Access Compliance Report Public Rights-of-Way (Pedestrian Signals)

Main Street: **ANTONIO_PKWY** Cross Street: **SENDERO_WAY** Location: **SW**

ADA ID: **SGRK211116133032** Signal Type: **One Push Button-Non APS** Overall Compliance: **No** Severity Scores: **BTN 1: 35** **BTN 2: N/A** **No BTN: N/A**

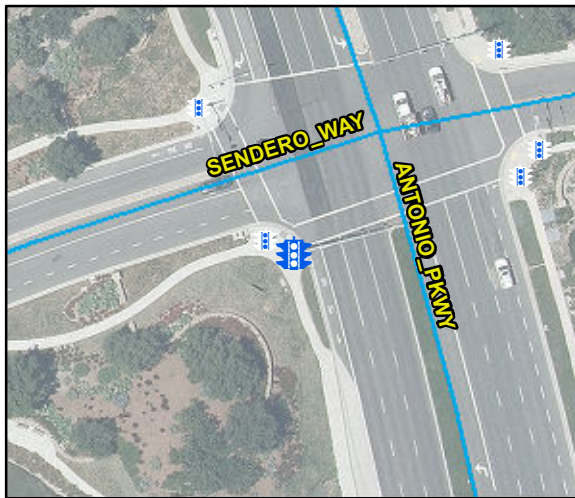
OC Std/PROW: **MUTCD 4e.08, R404.2**

Possible Solutions: Replace Signal Push Button With APS Button. Remove & Relocate Sign.
